A12 Chelmsford to A120 widening scheme

TR010060

9.66 Gershwin Boulevard Issue Summary Note

Gershwin Boulevard Issue Summary Note

Plate 2.1 Applicant's proposal for Gershwin Boulevard bridge

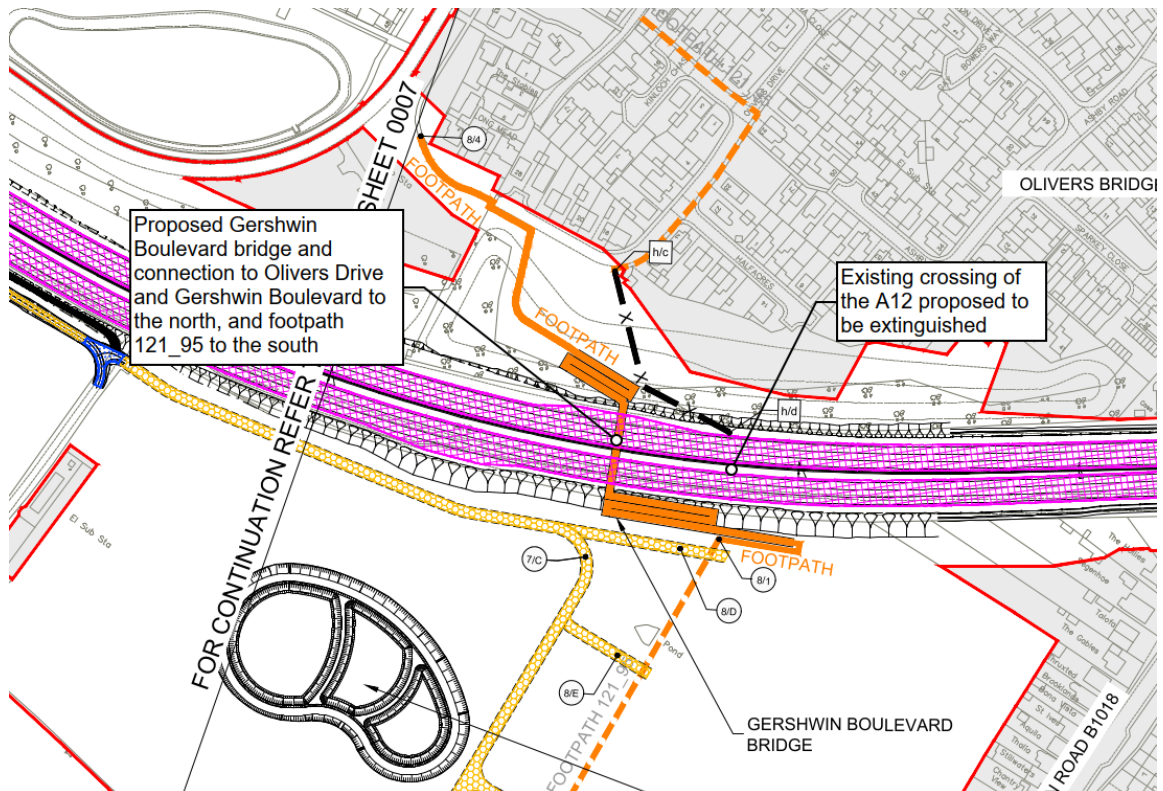
5.2.1 A number of Interested Parties have commented that they were not aware of the Applicant's proposal for the Gershwin Boulevard bridge prior to the submission of the DCO application and commencement of the examination period.

5.3.1 Interested Parties have raised that the existing public right of way 121_95 crossing of the A12 has not been useable since the opening of the A12 Witham bypass in the 1960's. The Interested Parties have raised that during the 60 years from when the crossing was severed to present day, a replacement crossing of the A12 has not been requested or desired by the residents, therefore it should not be required now.

- 5.4.1 There has been some confusion around the classification of the Gershwin Boulevard bridge upon opening that has led to Interested Parties raising concerns about this being a shared use walking, cycling and horse riding bridge.

- 5.4.2 The concern is that cyclists and horse riders will use residential streets to access the bridge.
- 5.4.3 Public right of way 121_95 is currently classified as a footpath and the nearby onward routes 121_107, 121_124 and 121_90 north of the A12 through Witham, and 121_96 south of the A12 are also classified as footpaths. As there are no onward cycling or horse riding routes in this area, the Applicant has proposed that the new Gershwin Boulevard bridge be dedicated for pedestrian and wheelchair use only.

5.2.2 The Applicant has provided details of the extensive consultation that was undertaken in 2021 in Section 2.2 of this note. Residents of Gershwin Boulevard, Olivers Drive, Maldon Road and the surrounding area were included in this consultation, the proposals for Gershwin Boulevard bridge were demonstrated in the consultation documents and responses were received from some residents in these locations.

5.3.2 As outlined in Section 2.1, the Applicant is proposing to divert the right of way for pedestrians between footpath 121_95 either side of the A12 with the new bridge providing a safe location to cross and allowing for the stopping up of the existing crossing of the A12 on the level. To facilitate the widening of the A12 in this location, the existing steps and central reserve barrier gap are proposed to be removed and a length of footpath 121_95 would need to be stopped up. Owing to the nature of the proposed scheme, the standards for its design require that pedestrians are prohibited from the altered A12. This would effectively confirm the current practical severance of the existing right of way owing to the volume of traffic and the safety concerns for pedestrians along with other classes of road user as described in DMRB GD300 who try to use the current legally permissible route. While this prohibition is primarily related to preventing pedestrians walking alongside the A12, it would also have the effect of prohibiting use of the current crossing of the A12 via the provided steps and central reserve barrier gap.

- 5.4.4 The bridge has been designed to accommodate cyclists and horse riders in the future, however the Applicant is not proposing to designate this as a shared use bridge. If in the future the local authority plans were to include additional cycle/bridleways in the area, the proposed bridge would facilitate a route here. As the bridge has a design life of 120 years and the only difference between a walking bridge and an equestrian bridge is the parapet height, the Applicant agreed with Essex County Council that designing the bridge to accommodate equestrian use in the future would be an appropriate future-proofing solution.

Plate 3.1 Alternative location for Gershwin Boulevard bridge

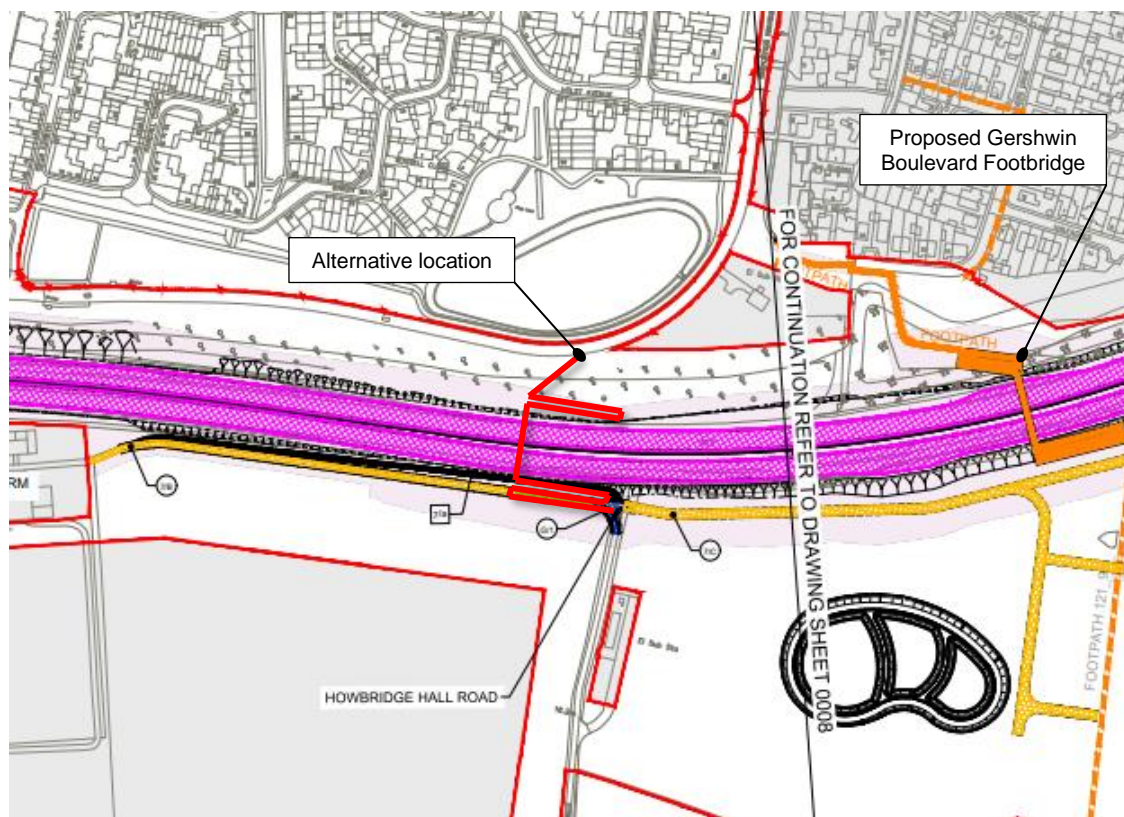
- 3.1.1 An alternative location for the new bridge has been suggested by Interested Parties. The suggested alternative location for the bridge is approximately 300 metres to the west of the proposed location, crossing the A12 from the south-eastern corner of the Maltings Lane development between Gershwin Boulevard to the north of the A12 and Howbridge Hall Road to the south of the A12.
- 3.1.2 The suggested alternative location for the new footbridge suggested by Interested Parties is annotated on Plate 3.1.

- 5.5.1 The location of the bridge has been questioned by Interested Parties and as described in Section 3, an alternative location has been proposed to cross the A12 in the vicinity of Howbridge Hall Road.
- 5.5.2 The Applicant has undertaken an assessment of this alternative location to understand the visual and ecological impact of the alternative location compared to the Applicant's proposed location.
- 5.5.3 As explained in Section 3, the alternative proposal does not resolve the concerns raised by the community but instead relocates the impacts on the receptors while increasing the diversion length of the public right of way that is being diverted.

- 5.12.3 The alternative proposal submitted by some Interested Parties connects to Howbridge Hall Road south of the A12 rather than footpath 121_95. The Interested Parties have suggested this route along Howbridge Hall Road would provide better connectivity to Maldon Road and the James Cooke Woods.

- 3.3.2 The alternative proposal relocates the crossing 300m west, and whilst the Applicant sees potential merit in the creation of a new footpath west of the proposed bridge, footpath 121_95 south of the A12 serves an area of Maldon Road with a number of premises and residences. The suggested route west of the bridge would ultimately connect to a section of Maldon Road remote from any built-up area, with no clear onward facility, and would not be considered by the Applicant to provide enhancement to the existing local Public Right of Way

network. Additionally, relocating the proposed bridge to the alternative location would result in a further 550m to 600m of diversion to the existing Public Rights of Way.

- 3.4.5 Although there are fewer visual receptors south of the A12 at the suggested alternative location when compared with at the Applicant's proposed location, the visual effects on visual receptors to the north of the A12 would be similar. Whilst the landscape and visual effects of a bridge in either location would likely be comparable, there would be greater scope for landscape and visual mitigation at the location proposed by the Applicant.

- 5.12.4 The Applicant does not consider the suggested location at Howbridge Hall Road to provide enhancement to the existing local Public Right of Way network as it would connect to a section of Maldon Road remote from any built up area with no clear onward facility that offers no benefit to users compared to footpath 121_95.

- 7.1.3 The Applicant has assessed the alternative proposal presented by the Interested Parties and found that the alternative proposal does not resolve the concerns raised by some of the Interested Parties and does not provide a significant improvement to the visual or ecological impacts, it simply relocates the impacts on the receptors to a different area.

Plate 3.2 Land plans within vicinity of Gershwin Boulevard Drive

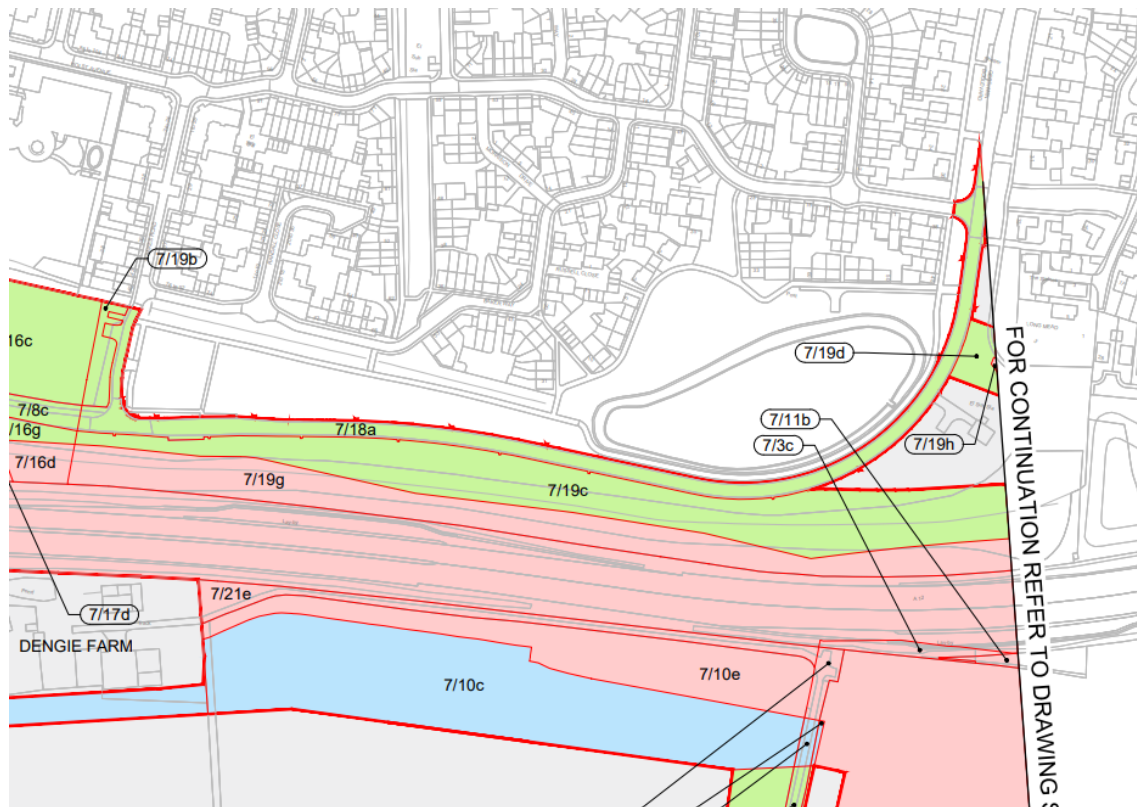
- 3.2.1 The alternative location for the new bridge is proposed to connect to Gershwin Boulevard south of an existing pond. This section of the proposed design is not within the proposed scheme's permanent land take as shown in Plate 3.2 (see plot 7/19c and 7/18a on sheet 7 of the Land Plans [REP4-005] for further details).

- 3.2.2 The proposed northern ramp would land within a group of semi mature trees which includes highway planting and trees for the screening of development, with no existing crossing. To implement a crossing at this location, land to the north of Gershwin Boulevard would be required which is outside of the proposed scheme's permanent acquisition.
